UNITED STATES PATENT AND TRADEMARK OFFICE

Office Action Summary

The following correspondence is a non-final Office Action for application # 10/550,394, entitled: PROJECTOR HOLDER, filed on 09/22/2005. Claims 1-11 are pending:

FIG 4

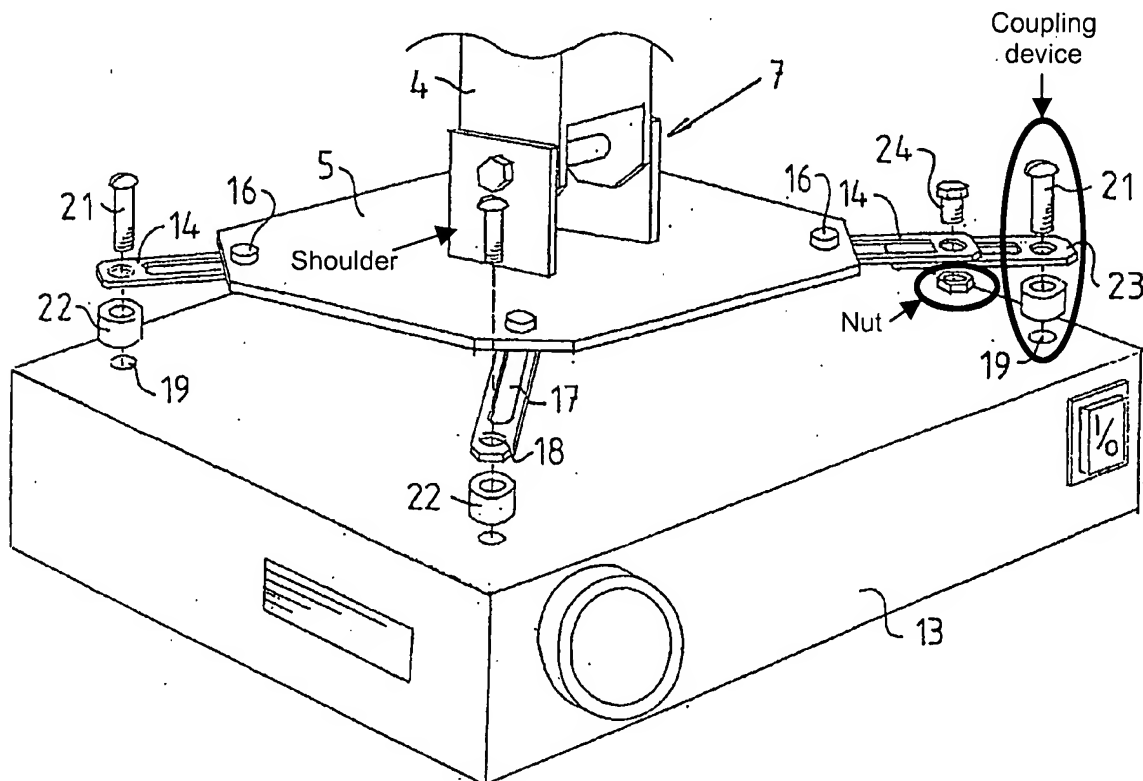
Regarding claim 1, Frisell discloses a projector holder comprising a connecting element 4 which includes a coupling element 7 for connection of the projector holder to a supporting structure, and at least three arms 14,15 which are carried by the connecting element 4 for rotation about mutually parallel axes and for radial displacement relative to the axes, so that a first end 23 of the arms 14,15 can be brought into alignment with threaded openings 19 in a wall of a projector housing 13, where each arm 14,15 carries a coupling device (as shown in Fig. 4 below) for

connecting the first end **23** of a respective arm **14,15** to a nearby threaded opening **19** in the wall of the housing **13**, and where the connecting element **4** is adapted to releasably secure the second end portions (via **16**) of the connected arms **14,15**, characterized in that the coupling device includes a screw **21** which extends through an opening **26** through the first end portion **23** of a respective arm **14,15** with a given degree of clearance, and two nuts (see Fig. 4 below, and discussion on pg. 6, lines 5-14 of specification) which co-act with the thread on the screw **21** and each of which is mounted on a respective side of the arm **14,15**, wherein the thread on the screw **21** is able to co-act with the thread in the opening **19** of the projector housing **13** wall, such as to enable the screw **21** to be screwed to a desired depth in threaded openings **19** in the housing wall **13**, where the nuts can be moved along the screw **21** in a manner to locate the arm **14,15** at a chosen distance from the housing wall **13** and such as to be tightened against the arm **14,15** and therewith secure the screw **21** against rotation.

With regards to claim 6, Frisell goes on to teach the projector holder, characterized in that the screw **11** of the connecting element **4** includes a shoulder (as shown in Fig. 4 below) that supports against an adjacent arm (via **5**).
